**Contract HK 12/02**  
**Central Reclamation Phase III – Engineering Works**  
**Environmental Permit No.: FEP- 01/122/2003**

**Certification and Verification for Change of FEP Condition 3.2 –  
Increased Dredging Rate at FRAW, Concurrent Dredging/ Filing at FRAW & FRAE**

**ET Leader's Certification**

Sketch A

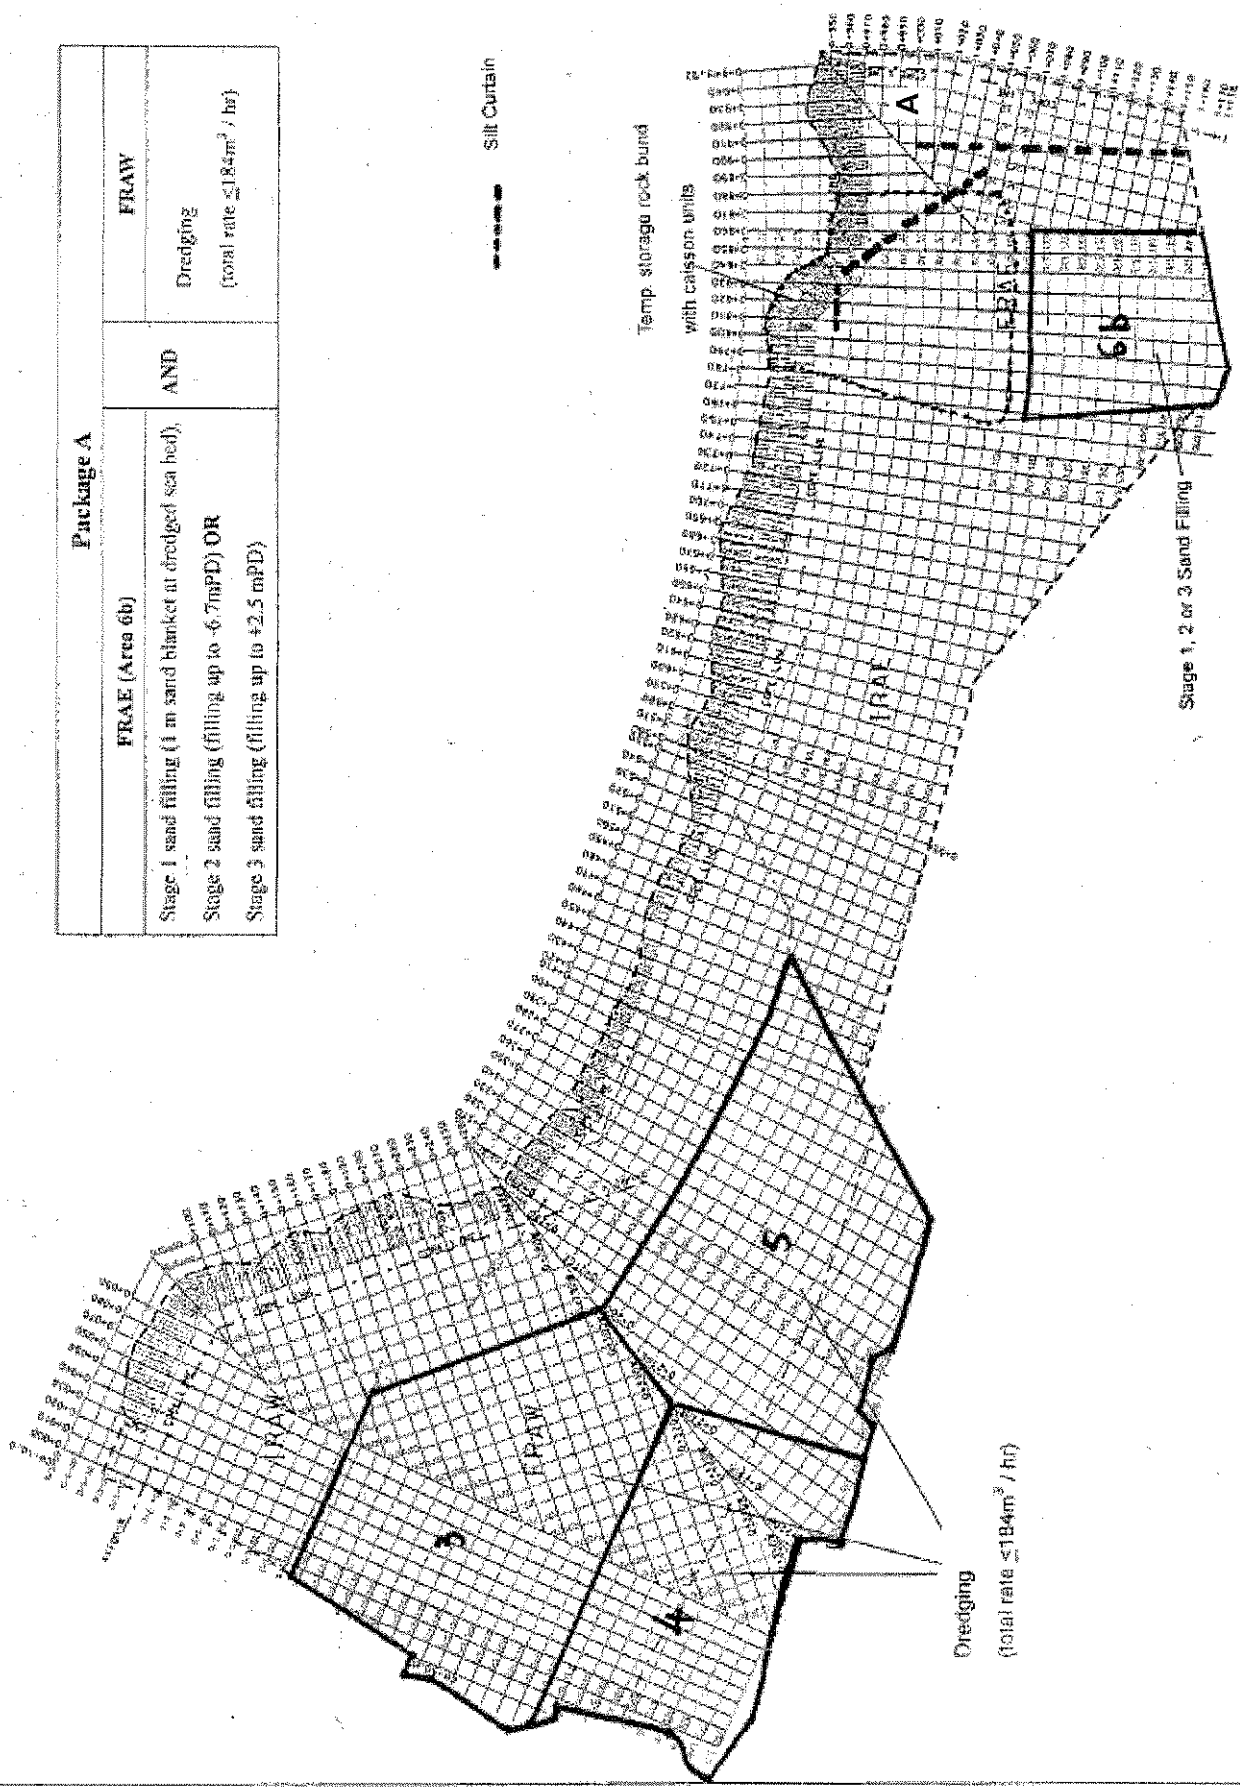
**Package A: Independent sand filling at FRAE and dredging at FRAW (Sketch A refers)**

FRAE	AND	FRAW
Stage 1: Sand filling (1m sand blanket on dredged sea bed together with removal of armour rocks and underlayer for eastern seawall of FRAE) OR Stage 2: Sand filling up to -6.7mPD OR Stage 3: Sand filling up to +2.5mPD together with temporary diversion of Culvert K	AND	Dredging at Area 3 OR 4 OR 5 at maximum dredging rate not exceeding 184m <sup>3</sup> /hour

(3) For sand filling works at FRAW or FRAE, two overlapping silt curtains with an opening for vessels movement shall be installed to enclose the sand filling area down to the seabed to avoid dispersion of fill materials as shown in Sketch A & B. These silt curtains shall be regularly inspected and fixed.

The ET has accepted the proposed mitigation measures and requires the following additional measures to be included as conditions of this certification:

(2) For Packages A and B, dredging at FRAW shall not exceed the maximum rate of 184m<sup>3</sup>/hour prescribed in the FEP. This should be defined as the cumulated total from all dredgers, if applicable.

Sketch B

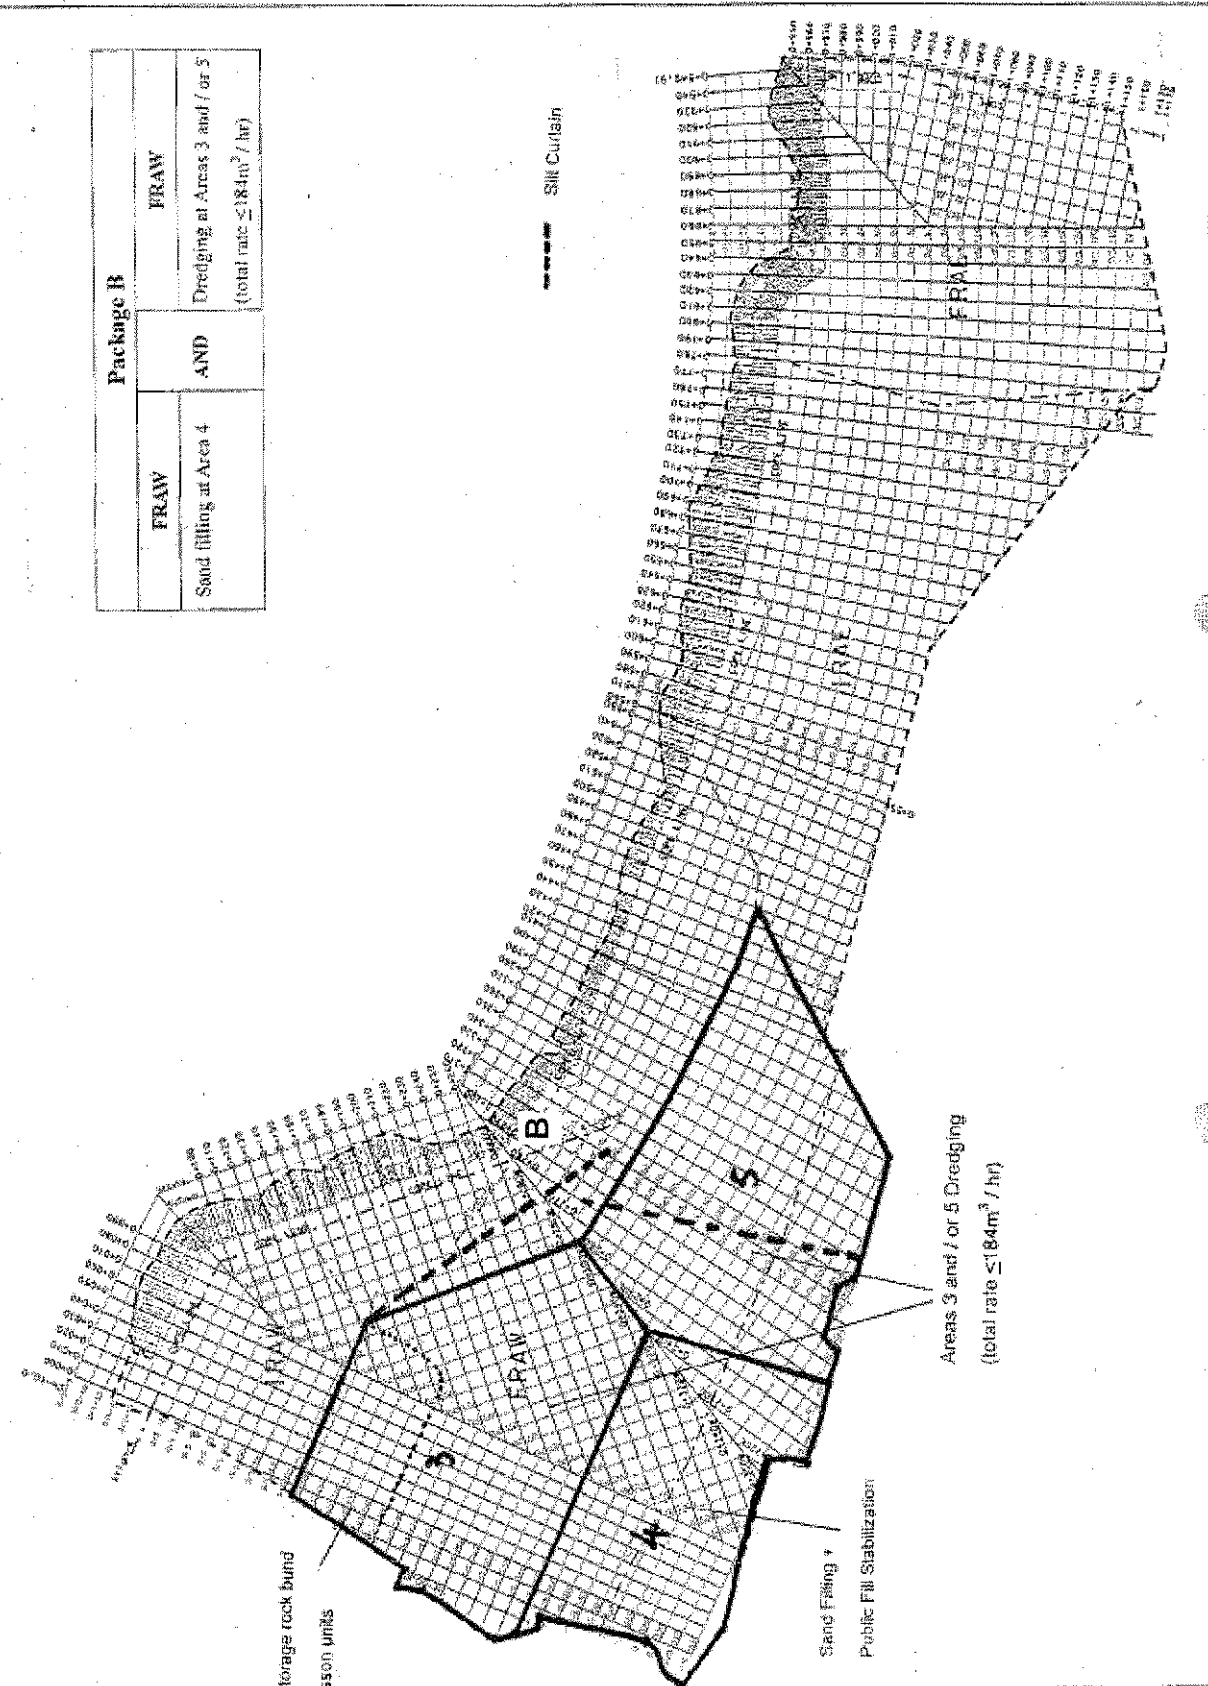
**Package B: Concurrent Dredging and Filling at FRAW (Sketch B refers)**

FRAW	FRAE
Sand filling in Area 4 together with sand slope stabilization by Type A materials + concurrent dredging at Area 3 AND / OR 5 at maximum dredging rate not exceeding 184m <sup>3</sup> /h	NO concurrent sanding filling at FRAE

(7) For works at FRAW, sand filling should be limited to Area 4 together with the necessary fill slope stabilisation by Type A materials only. Further restrictions on filling works in the FEP - Clause 3.3 shall apply.

Sketch C

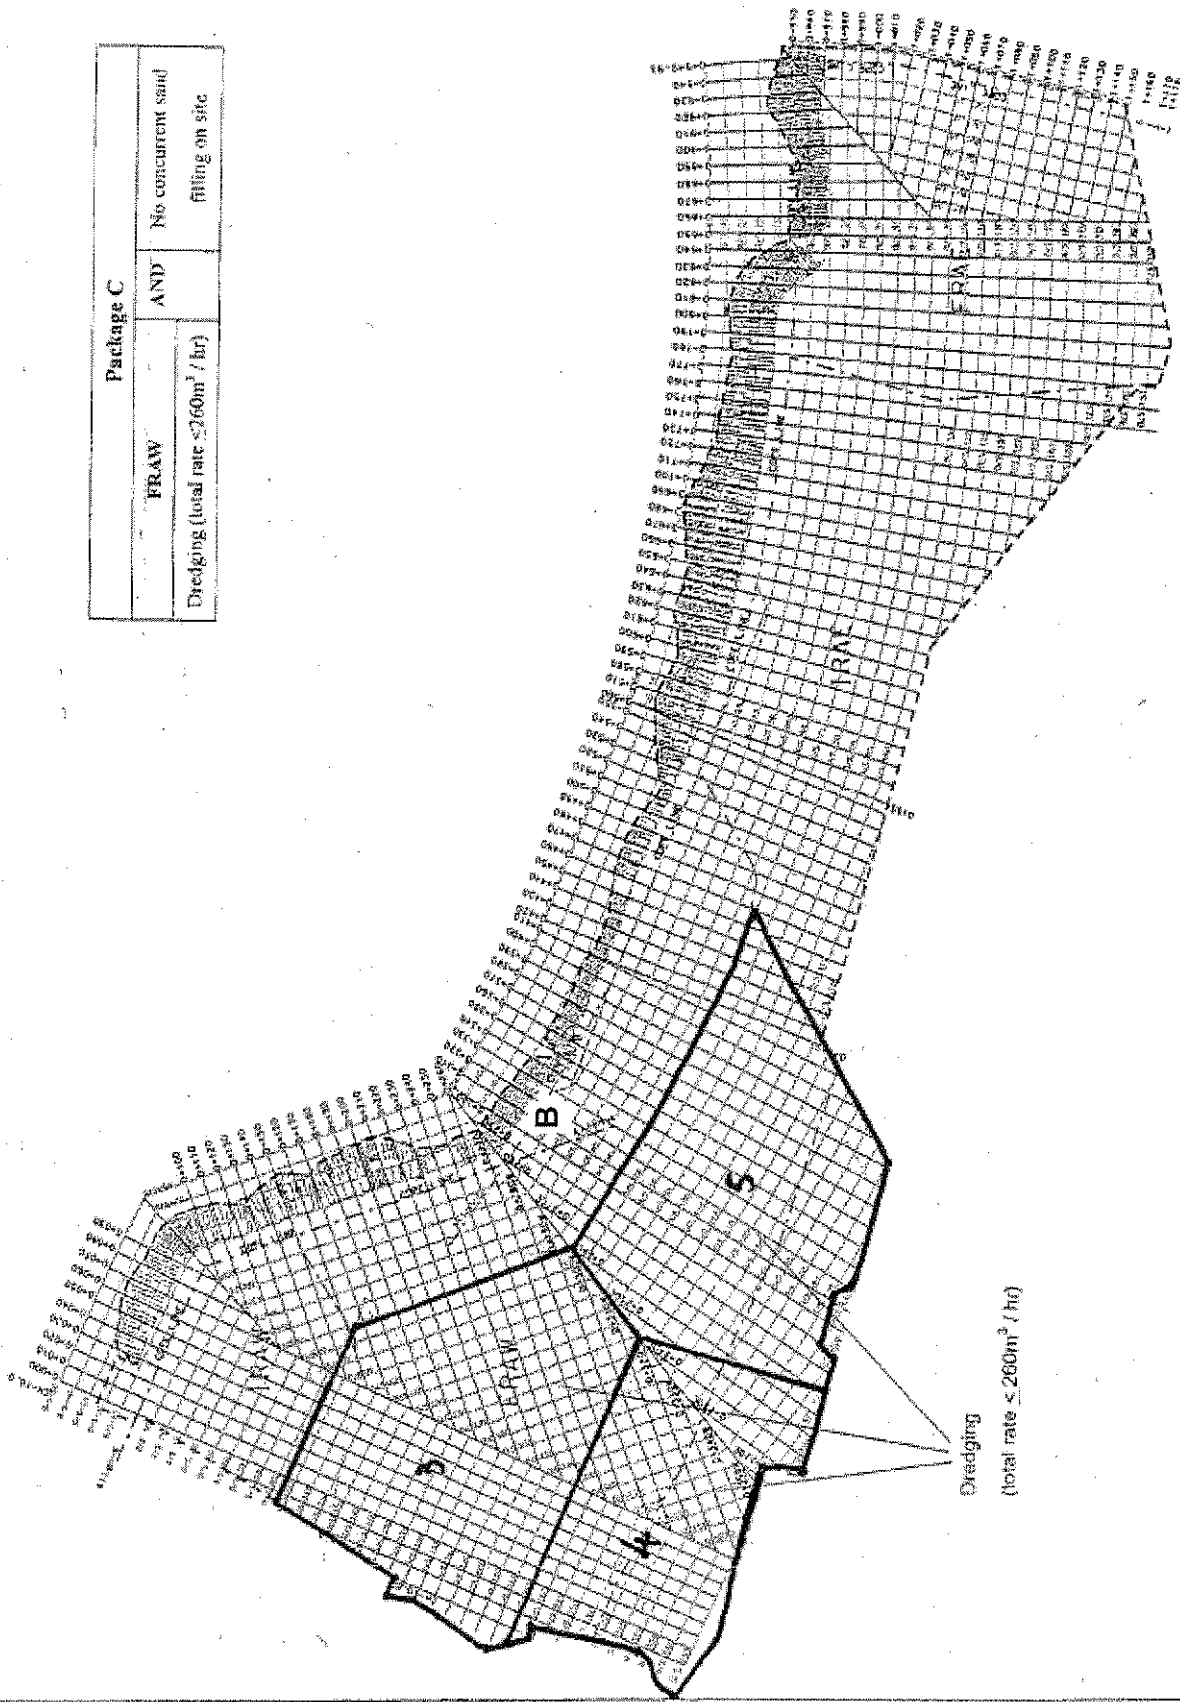
**Package C: Dredging at FRAW (Sketch C refers)**

FRAW	FRAE
Dredging at FRAW with total dredging rate not exceeding 260m <sup>3</sup> /hour. No concurrent sandfilling at FRAW.	NO concurrent sanding filling at FRAE
